DISTRICT 4 ROAD SAFETY AUDIT REPORT

SOMERSET CANYONS ACADEMY SR-804 (BOYNTON BEACH BOULEVARD) FROM SR-7 (US-441) TO LYONS ROAD

PREPARED FOR:
FLORIDA DEPARTMENT OF TRANSPORTATION, DISTRICT 4

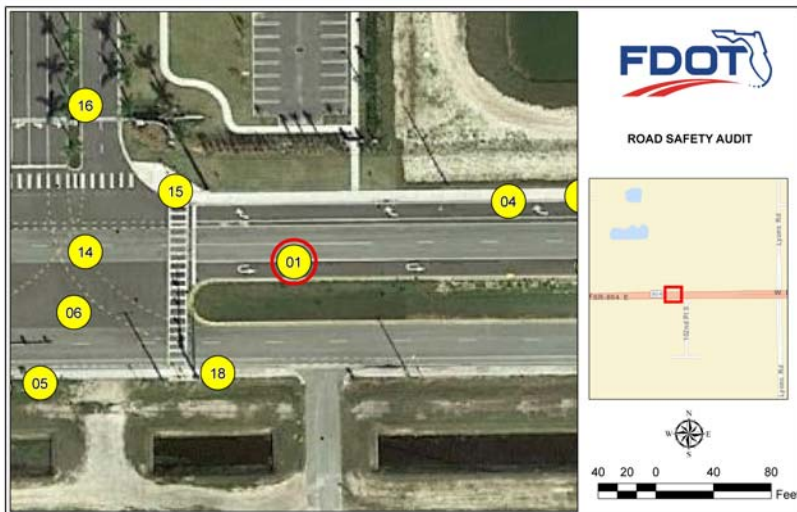
ID	Location Description:	Observation Overview:	Suggestions for Consideration:
01	SR-804 (Boynton Beach Boulevard) east and west of Somerset Canyons Academy.	New School Zone signage is not per FDOT standard.	Upgrade School Zone signage.

The new pedestrian signage is not per FDOT standards for multilane highways. In particular, the "time of day" signs are specified for use on 2-lane roadways, and static signs do not take into account early dismissal days. In addition, the 20 MPH zone for Somerset Canyons Academy is difficult to detect due to sign placement and sign messages.

Review upgrades to the School Zone signage per FDOT Index 17344 Sheet 3 and corresponding MUTCD guidance. Specifics include the following: remove the "time of day" signs and use "when flashing" beacons; relocate advance signage outside of turn lane limits, east of Somerset Canyons Academy, and further in advance of the zone.

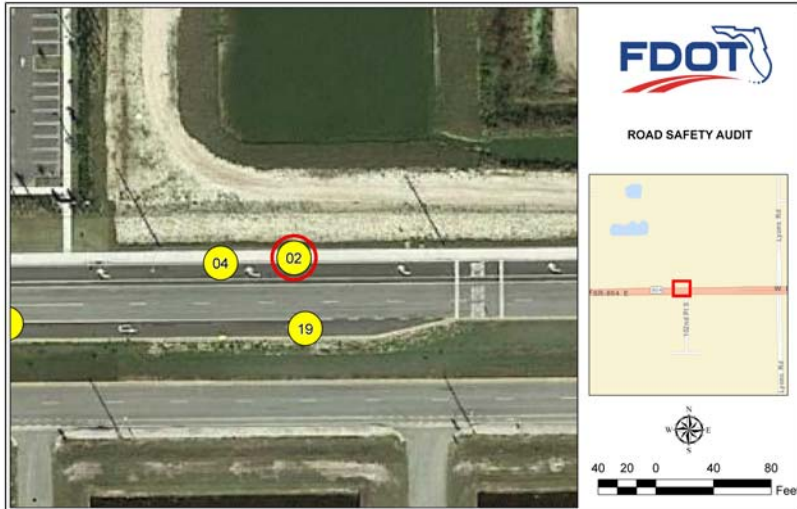
ID	Location Description:	Observation Overview:	Suggestions for Consideration:
02	Westbound right-turn lane into Somerset Canyons Academy.	Queuing cars can obstruct visibility of School Zone signs.	Relocate School Zone signage.

When westbound right-turning cars queue in the turn lane, it creates an obstruction of School Zone signage, which is already difficult to see.

Reevaluate placement and layout of School Zone signs and consider enhanced placements or additional signage beyond the standard requirements. Combine this recommendation with other recommendations related to School Zone signage. See FDOT Index 17344.

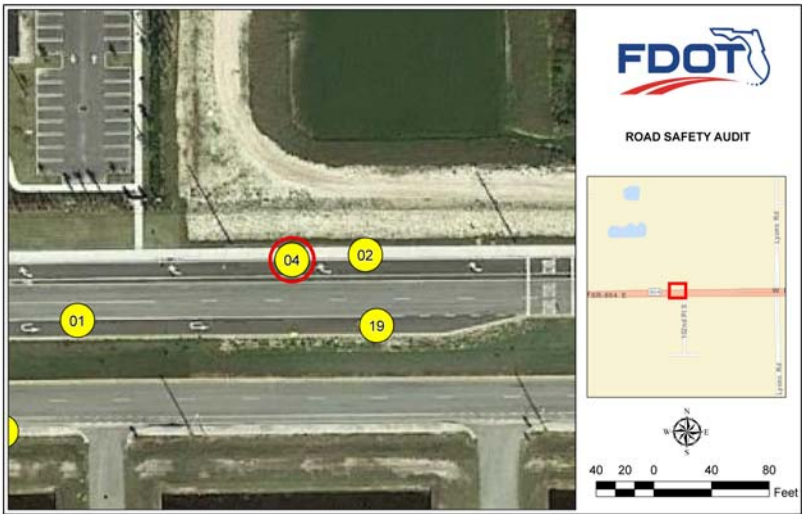
ID	Location Description:	Observation Overview:	Suggestions for Consideration:
04	School Zone driveway.	Advance School Zone sign is obstructed.	Relocate sign.

The new advance School Zone sign is obstructed by two poles and is not placed adjacent to the "SCHOOL" pavement marking.

Relocate the sign adjacent to the "SCHOOL" marking for improved visibility. See previous comments related to the school zone signage.

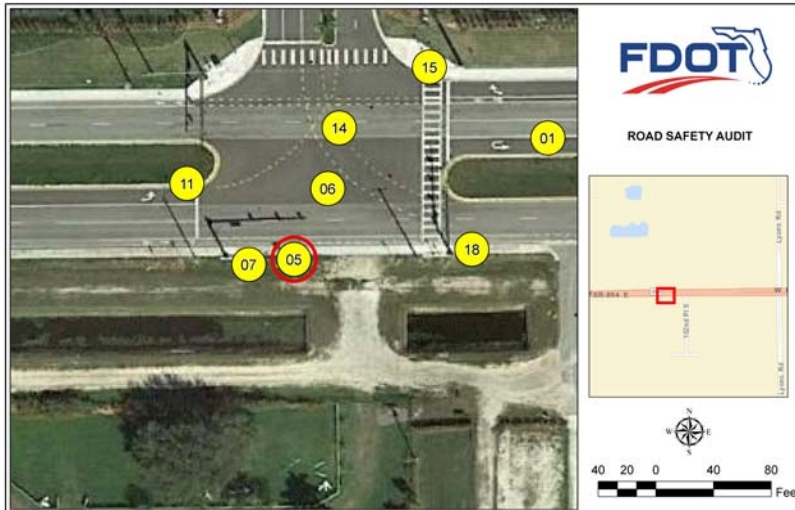
ID	Location Description:	Observation Overview:	Suggestions for Consideration:
05	South side of SR-804 (Boynton Beach Boulevard) on eastbound approach to Somerset Canyons Academy.	Conflicting speed limit signs - 20 MPH and 45 MPH	Remove conflicting 45 MPH sign.

For the eastbound approach, there is a 20 MPH School Zone sign approximately 20 feet in advance of a 45 MPH speed limit sign. Both signs are within the limits of the school zone. There can be confusion and ambiguity if a typical regulatory speed limit sign is displayed after a school speed limit sign. In some jurisdictions, the regulatory sign is considered an indication of the end of the school zone. Applicable references include F.S. 316.1895, and MUTCD Chapter 7B.15.

Remove the conflicting 45 MPH sign and relocate it outside of the school zone, to the east. Consider installing the sign on the same post as the "End School Zone" sign consistent with MUTCD Chapter 7B.15, Option 06.

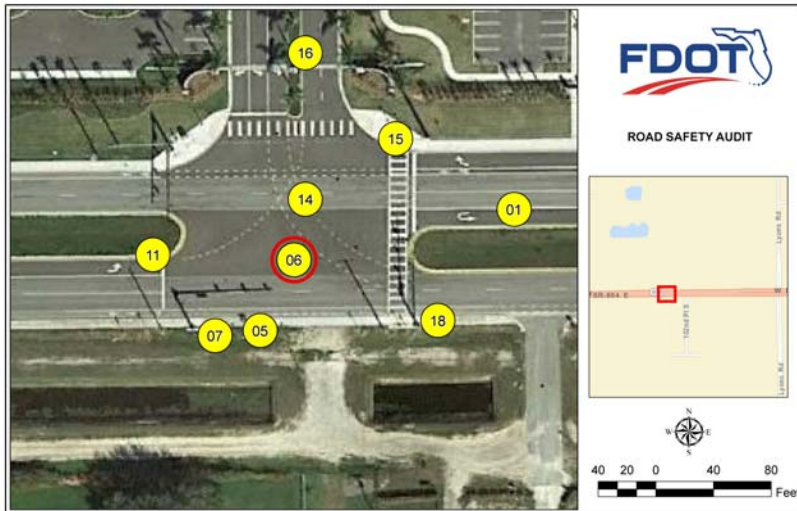
ID	Location Description:	Observation Overview:	Suggestions for Consideration:
06	Within school zone limits east and west of Somerset Canyons Academy.	No bright sticks or reflective tape on School Zone signage.	Increase visibility by adding reflective tape or bright sticks to School Zone sign pole.

No bright sticks or reflective tape on School Zone signage.

Increase the visibility of School Zone signs by adding reflective tape to the pole. Note: This recommendation should be considered with other sign recommendations herein.

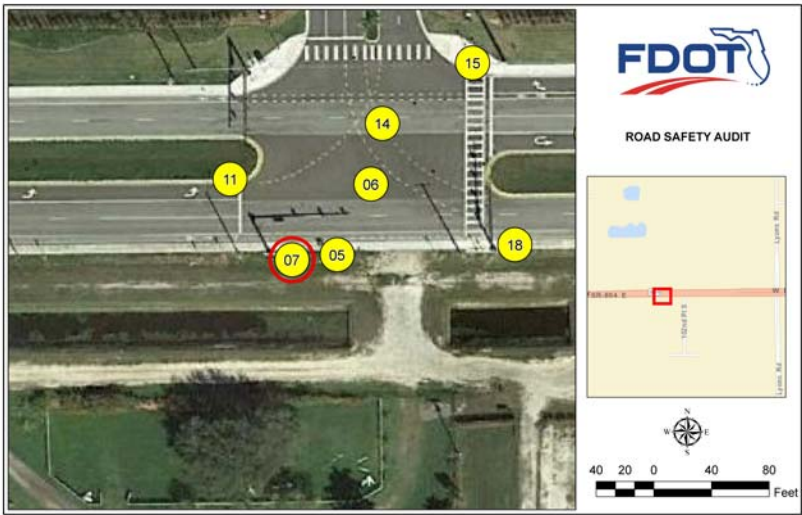
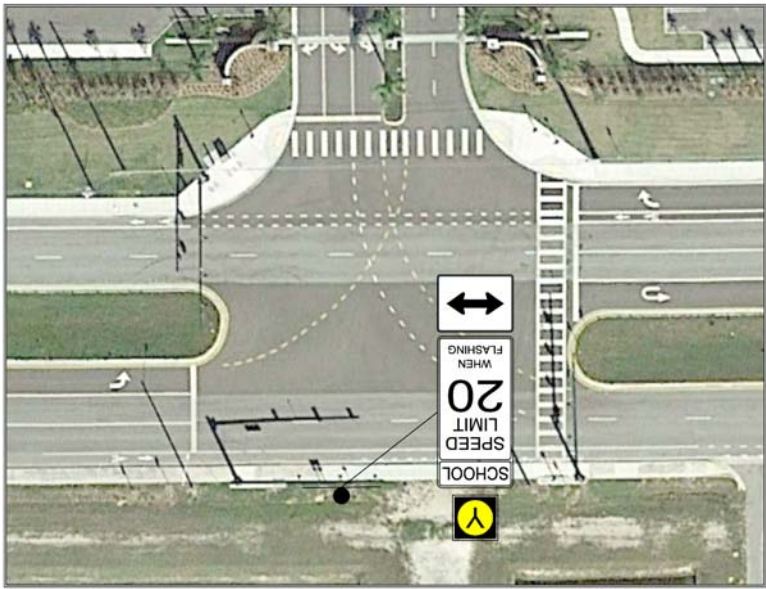
ID	Location Description:	Observation Overview:	Suggestions for Consideration:
07	Somerset Canyons Academy driveway.	No "School Zone" signs for exiting vehicles.	Consider signage for exiting vehicles.

In the field, cars exiting Somerset Canyons Academy were observed exceeding 20 MPH within the designated school zone. There have been instances in which people leaving Somerset Canyons Academy property successfully fought a speeding ticket by claiming they did not know they were in a reduced-speed school zone.

Add signing to communicate the reduced speed school zone to vehicles exiting the school.

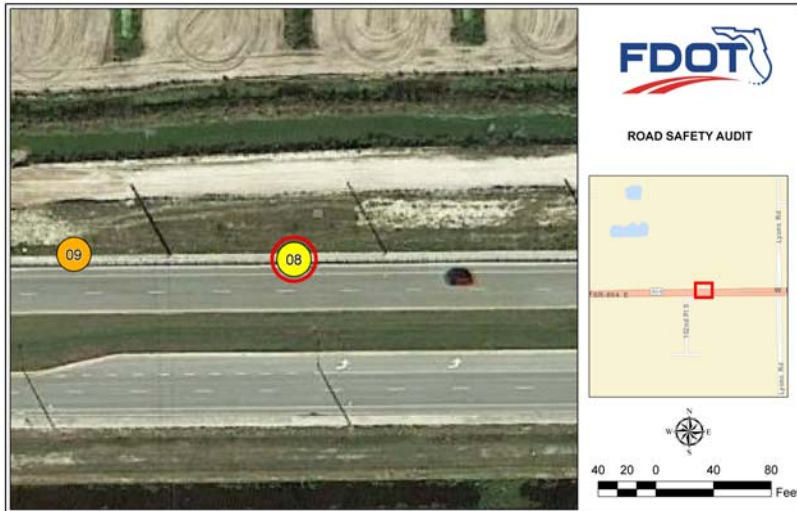
ID	Location Description:	Observation Overview:	Suggestions for Consideration:
08	North side of SR-804 (Boynton Beach Boulevard) from east of Somerset Canyons Academy to Lyons Road.	The existing guardrail along sidewalk is no longer warranted.	Evaluate and potentially remove guardrail.

Based on the field review, approximately one fifth to one quarter of students walk and bike along the northside of SR-804 (Boynton Beach Boulevard) to the east . The sidewalk in this area, between the school and Lyons Road, is shielded by guardrail. The guardrail was installed, previously, to shield vehicles from a drainage canal. This canal has since been filled in.

As the original hazard is no longer present, conduct an analysis to determine if the guardrail can and should be removed. As the guardrail does serve to keep students out of the roadway and on the sidewalk, if it is removed, consider a pedestrian fence treatment per developmental FDOT standards. See Appendix, "Discussion A" for details.

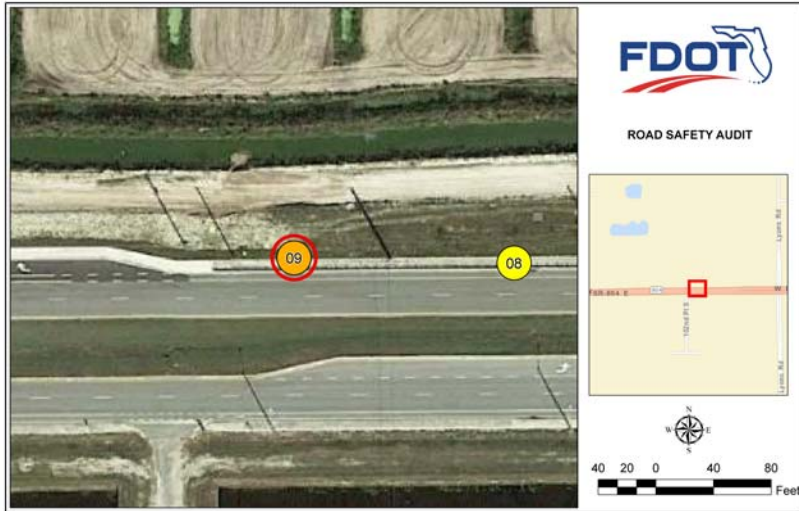
ID	Location Description:	Observation Overview:	Suggestions for Consideration:
09	Along SR-804 (Boynton Beach Boulevard) between Lyons Road and SR-7 (US-441).	Several street lights are out.	Repair nonoperational street lights.

During a morning review (pre-dawn), several street lights were observed to be out on both the north and south sides of the roadway.

Conduct maintenance on the nonoperational lights (bulb replacement, photocell, circuit, etc.)

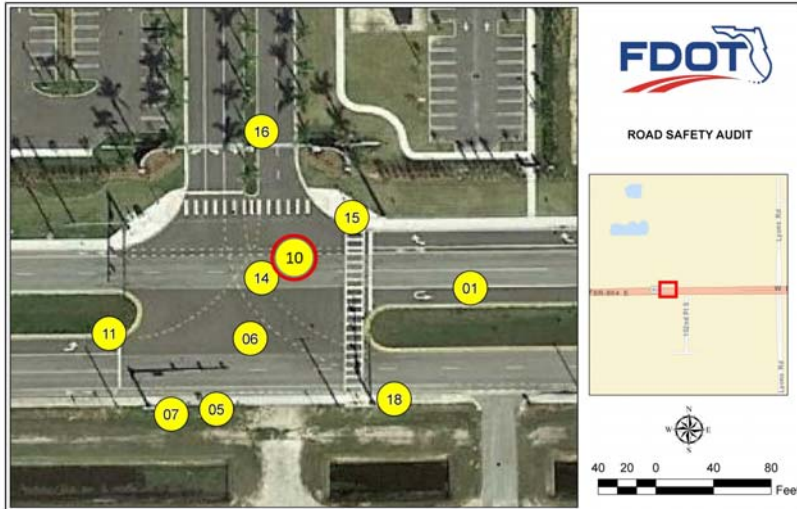
ID	Location Description:	Observation Overview:	Suggestions for Consideration:
10	Westbound approach to Academy driveway.	High speed westbound right turns into the Somerset Canyons Academy driveway.	Consider flashing yellow arrow

The parents turning right into Somerset Canyons Academy travel at a high speed (large turn radius) and make right turns on red at speed. These vehicles can conflict with both pedestrians crossing and pedestrians existing the grounds through the driveway.

This could be a multi-tier solution. Combine with previous recommendation:

- Have a "No Right Turn on Red" condition. Note this could cause significant westbound queue spillover.
- Have a "Blankout" NRTorR restriction that only activates when the pedestrian crossing is activated across the east leg.
- Use human control and presence similar to AM Peak. See previous recommendation.

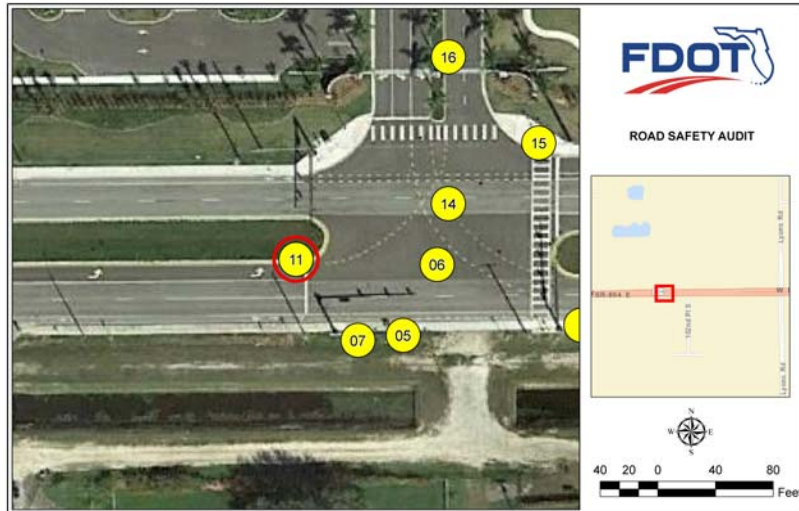
ID	Location Description:	Observation Overview:	Suggestions for Consideration:
11	Somerset Canyons Academy driveway.	Existing crosswalk on east leg of SR-804 (Boynton Beach Boulevard) conflicts with major vehicular movements.	Relocate crossing to west side of the driveway.

There is a crosswalk on the east leg of the Somerset Canyons Academy driveway crossing SR-804 (Boynton Beach Boulevard). In the PM peak, there is significant westbound right-turning traffic generated by cars entering the school for pickup. Many of these movements are made as "right turn on red," which directly conflicts with the protected pedestrian phase. In addition, these right-turning vehicles are in conflict with students walking from the school, through the driveway, to the northeast quadrant of the intersection. In addition, the pedestrian phase cannot operate when the southbound left-turn phase from the school is green. It should be noted that it is estimated that 70-80% of school traffic is executing these movements (to/from the east).

Consider relocating the crosswalk to the west side of the Somerset Canyons Academy driveway. In conjunction with this, provide an on-site gated sidewalk access to this quadrant. Review the potential to provide a sidewalk through the planter on the west side of the property at the location of the existing on-site crosswalk. This sidewalk would connect, through a gate, to the northwest quadrant of the signalized intersection. Note, also, there is an existing street light along this potential crossing and not at the existing crossing. The relocated crossing would reduce the pedestrian/vehicle conflicts at the signalized intersection and within the driveway. See Appendix Figure 1 and Figure 2.

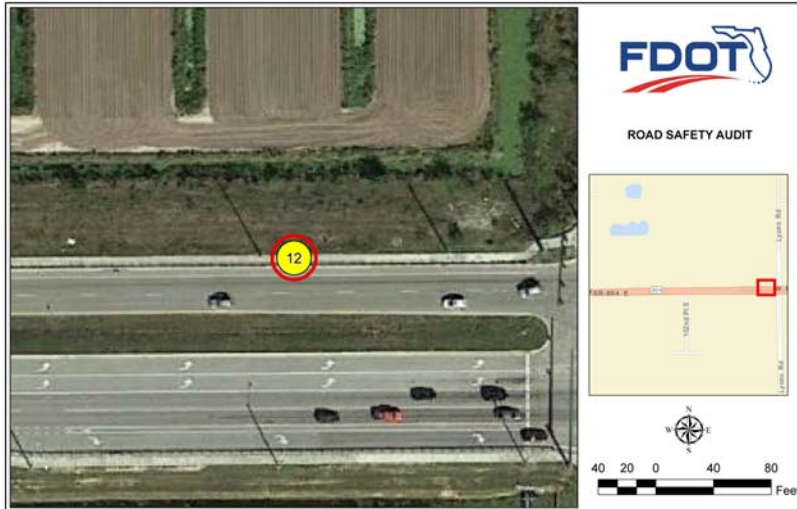
ID	Location Description:	Observation Overview:	Suggestions for Consideration:
12	North side of SR-804 (Boynton Beach Boulevard), west of Lyons Road.	Utility poles obstructing sidewalk.	Relocate utility poles.

Two utility poles are obstructing the sidewalk, resulting in substandard ADA clearance and a potential hazard to bicyclists.

Relocate the utility poles to the back of the sidewalk.

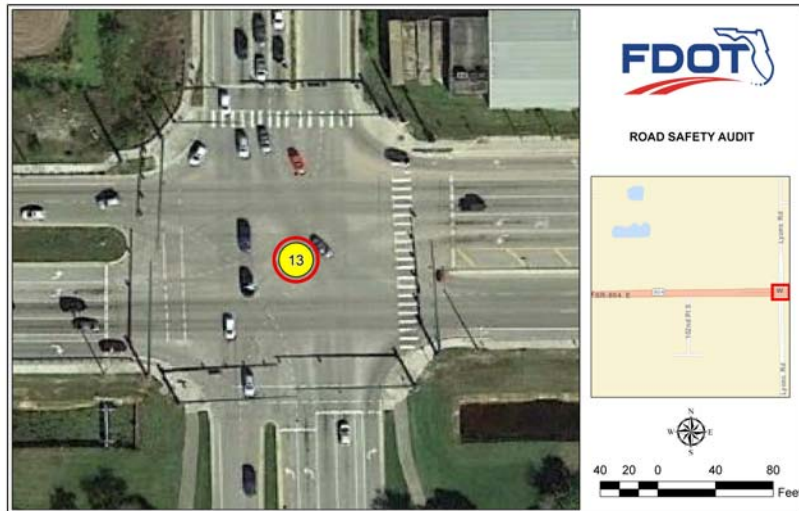
ID	Location Description:	Observation Overview:	Suggestions for Consideration:
13	Lyons Road & SR-804 (Boynton Beach Boulevard).	No crossing guard during Somerset Canyons Academy's departure times.	Consider supplementing or extending hours of crossing guards for Sunset Palms Elementary.

Sunset Palms Elementary School has crossing guards for its final bell from 1:45 PM to 2:30 PM. This is before Somerset Canyons Academy's final bells. Therefore, there are no crossing guards at Lyons Road for Somerset Canyons Academy students. The guards significantly improve driver compliance with pedestrian movements, in particular the right-turn movements.

Consider extending the hours of the crossing guards at this location, if feasible. Coordinate with PBCSO.

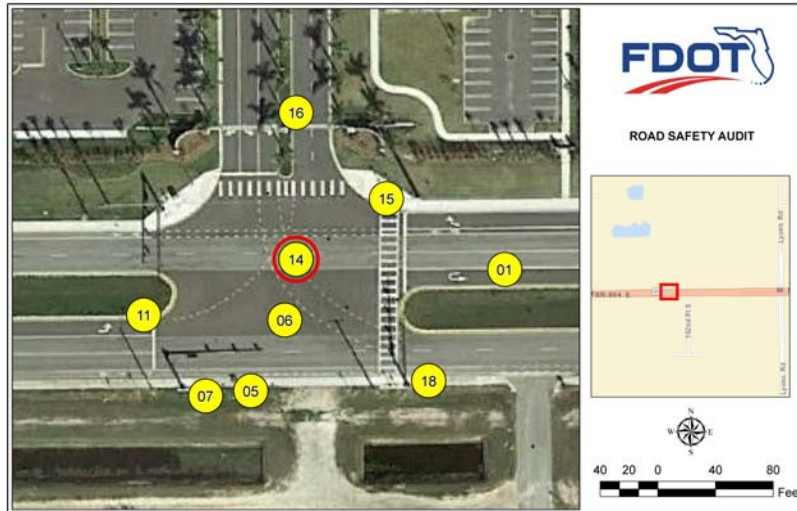
ID	Location Description:	Observation Overview:	Suggestions for Consideration:
14	Intersection of Somerset Canyons Academy and SR-804 (Boynton Beach Boulevard).	During the AM, a security guard directs westbound right-turning and eastbound left-turning traffic into the driveway.	Consider security guard in the PM peak as well.

During the AM drop off, a security guard directs westbound right-turning and eastbound left-turning traffic into the Somerset Canyons Academy driveway. The goal of this staffing is to maintain traffic flow (in particular, the westbound right turn on red). By maintaining traffic flow, the westbound right turn rarely queues into the through lanes.

As mentioned in other observations, during the PM departure, students were observed walking southbound from the school driveway to the northeast quadrant of the signal. There is also a significant conflict between westbound right turns on red and the pedestrians crossing in the crosswalk. This position could be staffed during the PM peak hour as well to balance traffic flow and pedestrian safety. Note that this position should obtain training as a Traffic Control Officer for Civilians. This class is offered through the Florida Department of Law Enforcement (Course Number 732) Note: Operationally, manual control of this movement would be preferable to enforcing a "No Right Turn on Red" condition (see other recommendations related to driveway operation).

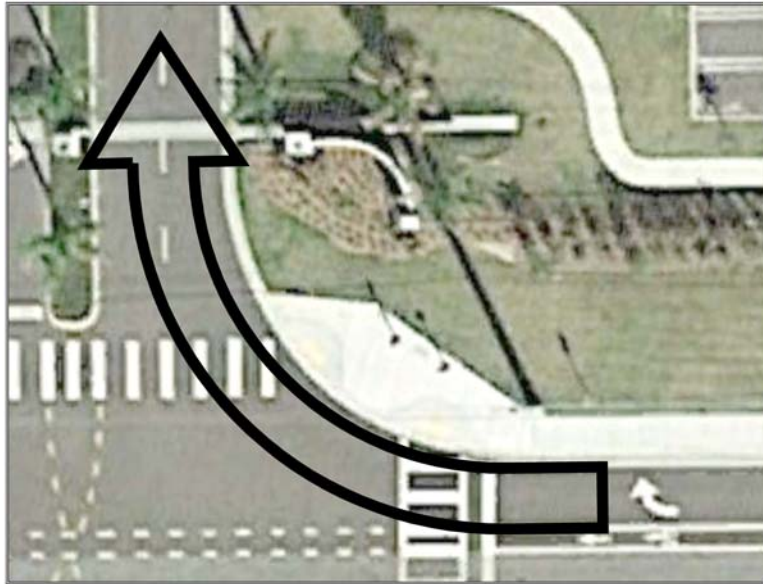
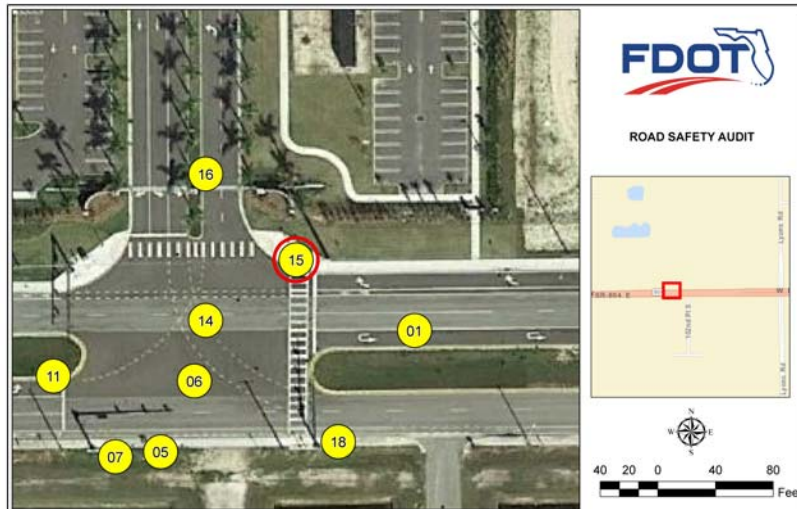
ID	Location Description:	Observation Overview:	Suggestions for Consideration:
15	Westbound right turn from SR-804 (Boynton Beach Boulevard) into Somerset Canyons Academy.	High speed right turns into Somerset Canyon Academy conflict with difficult sight lines to pedestrians walking southbound out of the school.

Westbound right-turning vehicles (parents into school) are traveling at a high speeds into Somerset Canyons Academy. Many walking and biking students exit school grounds through the gate to get to the northeast quadrant of the signalized intersection. There is very little grass strip to walk on and minimal visibility.

Short term: Inform parents and consider R10-15 signage or other "Watch for Pedestrians" signage. Mid term: Consider a "blank out" no right turn sign for when the pedestrians are actuated across the east leg. However, traffic control by security is preferable (see comment related to security). Long term: Consider a sidewalk connection from the school property, east of the gate, to the sidewalk on the northeast quadrant.

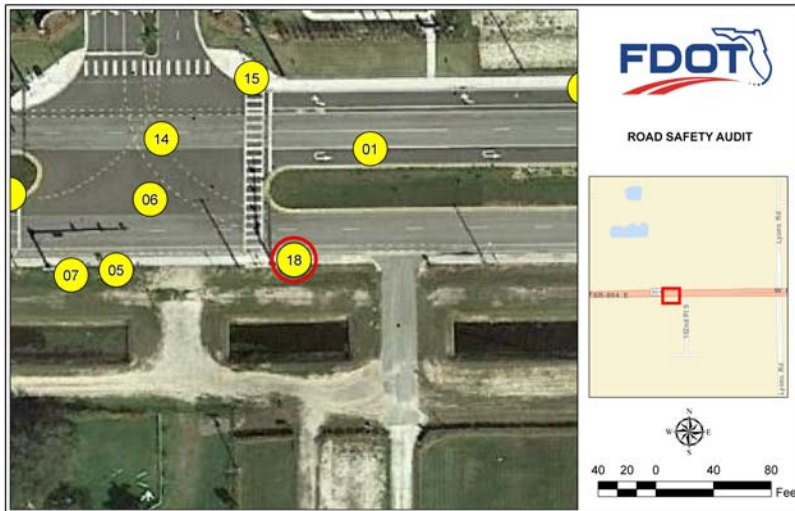
ID	Location Description:	Observation Overview:	Suggestions for Consideration:
18	Sidewalk on south side of SR-804 (Boynton Beach Boulevard).	Very high pedestrian and bike volume along the 5-6' sidewalk.	Coordinate with property owner to determine feasibility of a larger offset shared use path.

The majority of students walk along the south side of SR-804 (Boynton Beach Boulevard). The sidewalks conform to FDOT standards (5' minimum width). However, the crowding and shared use by pedestrians and bicyclists is not an ideal scenario.

Given the high pedestrian and bicycle volume and the proximity to a school, coordinate with the adjacent property owners (assumed to be a water management district) to determine the feasibility of installing a wider pathway within in an easement (see PPM Section 2.1.4.1).

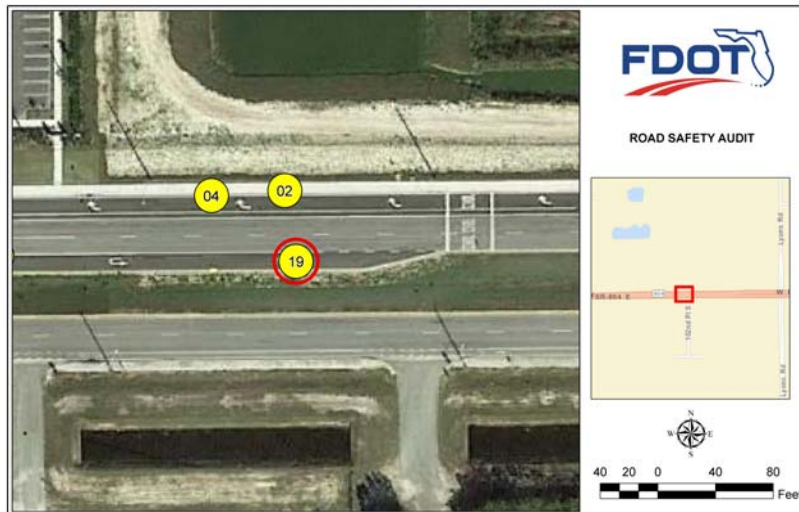
ID	Location Description:	Observation Overview:	Suggestions for Consideration:
19	Along SR-804 (Boynton Beach Boulevard) within School Zone of Somerset Canyons Academy.	Law enforcement presence observed	Encourage law enforcement presence (passive or aggressive).

On the day of the field review, a law enforcement officer was observed within Somerset Canyons Academy limits during the AM departure. He was positioned in highly visible locations, and it appeared that the presence increased the likelihood of driver compliance. A discussion with the Principal indicated this is not typical for PBCSO to be in the school vicinity.

To improve compliance with the speed zone, several recommendations could be considered: Improve driver notification (overhead signs and/or beacon signs - see other sign recommendations) Employee DMS and/or speed feedback signs to notify drivers of new School Zone and new regulatory speed; dispatch police presence to area to provide passive, educational, and enforcement regulation of School Zone regulations.
